STAFF RECOMMENDATION 928 Montrose Avenue November 19, 2018

Application: New Construction - Addition
District: Waverly-Belmont Neighborhood Conservation Zoning Overlay
Council District: 17
Map and Parcel Number: 11801030800
Applicant: Kaitlyn Smous, Nine 12 Architects
Project Lead: Melissa Sajid, melissa.sajid@nashville.gov

Description of Project: The application is for a rear and side addition.

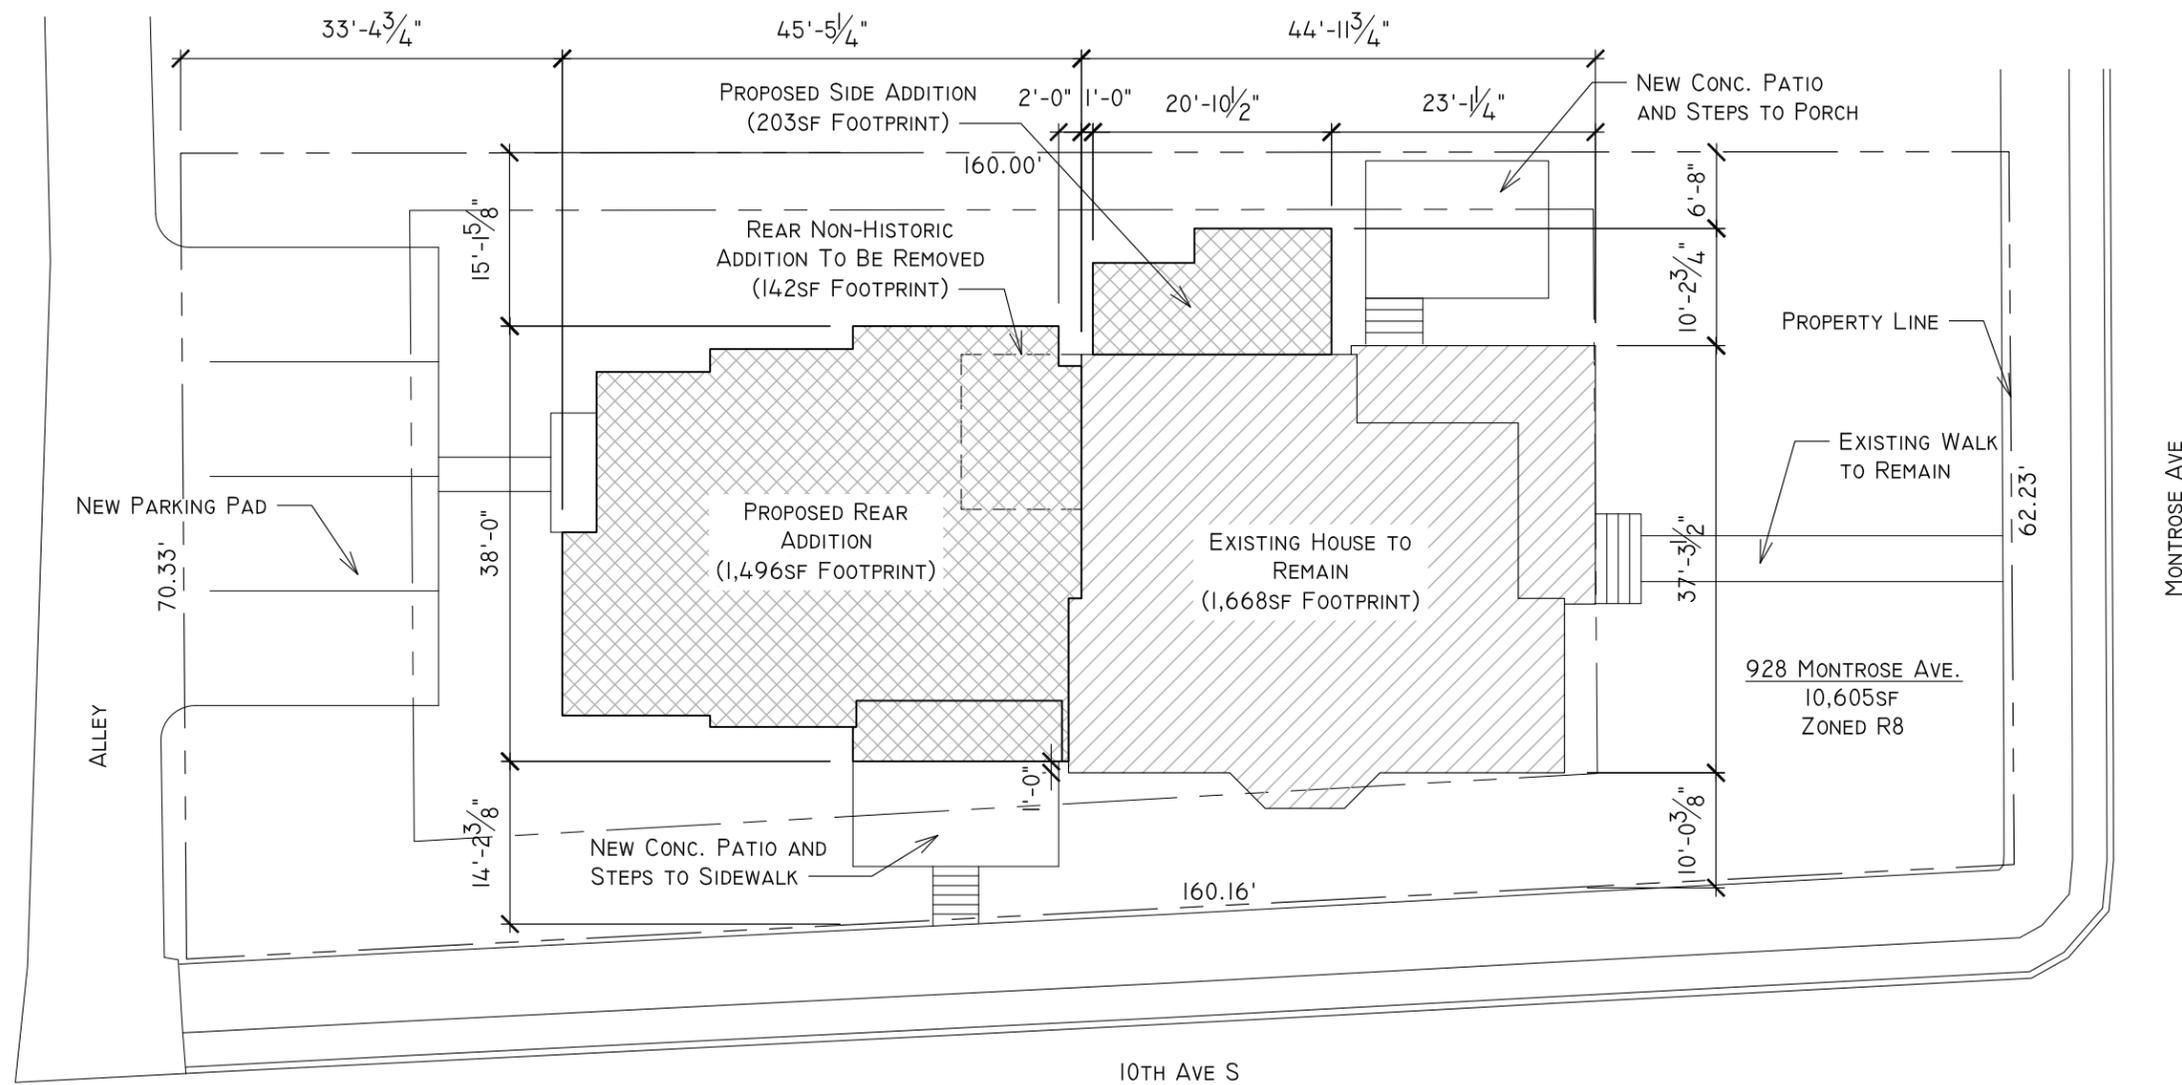
While the rear addition is not taller than the peak of the historic house, there is a small portion on the right side façade that is wider than the historic house and taller than the proposed side addition (Figure 5). The design guidelines states that, while it may be appropriate for an addition to rise above or extend wider than the existing building, the addition should not be taller and wider. Staff recommends that the rear addition not be taller and wider on the right side.

1. The rear addition shall not be taller and wider on the right side;
2. Staff review the final selection of materials for the roofing color, doors, and rear porch roof prior to purchase and installation; and
3. The HVAC be located on the rear façade, or on a side façade beyond the midpoint of the house.
